Subject: Almond 2 Power Plant (09-AFC-02)
Hughson-Grayson 115kV Transmission Line and Substation Project, Revised
Draft Environmental Impact Report, dated July 23, 2010, Applicant's Exhibit #__

Hughson-Grayson 115-kV Transmission Line and Substation Project

Final Environmental Impact Report

FIGURE LU-2

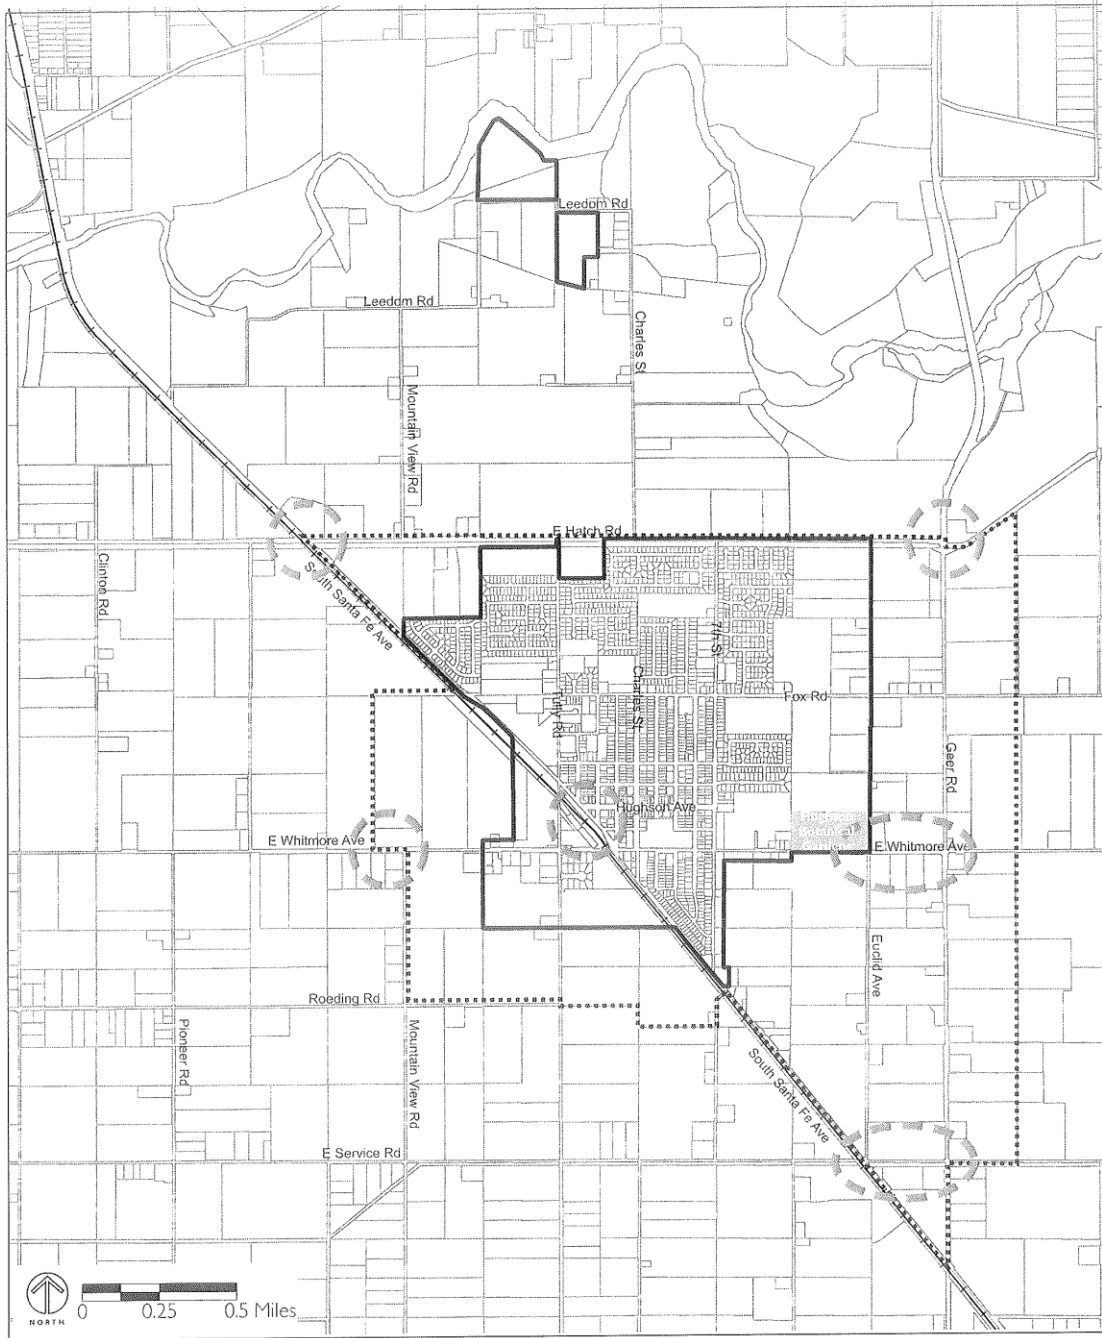
- 2-3 3. Both intersections of Whitmore and Euclid, as well as Service and Euclid are designated as Gateways in the City's General Plan. See attached Figure LU-2. Hughson's General Plan Land Use Element contains the following language regarding gateways.
"Gateways are entries to the city along major roadways. Creating aesthetically pleasing gateways is an important component of land use planning and community design that contributes to a city's character and sense of place. Gateway design treatments can include fountains, attractive signage or natural features such as rows of trees. The Hughson Botanical Gardens has indicated to the City that as part of the Gardens' improvement plan, it would like to partner with the City to create a gateway along Whitmore Avenue from Geer Road".
Protection of City Gateways is an effort we intend to vigorously pursue.

TID is aware of the city’s Gateway designation. The Project is consistent with this element of the city’s General Plan. The policies of the *Hughson General Plan* do not specifically exclude power structures from the gateways, and the presence of power structures would not preclude the development of visually pleasing gateways. No revisions to the Draft EIR are required in response to this comment.
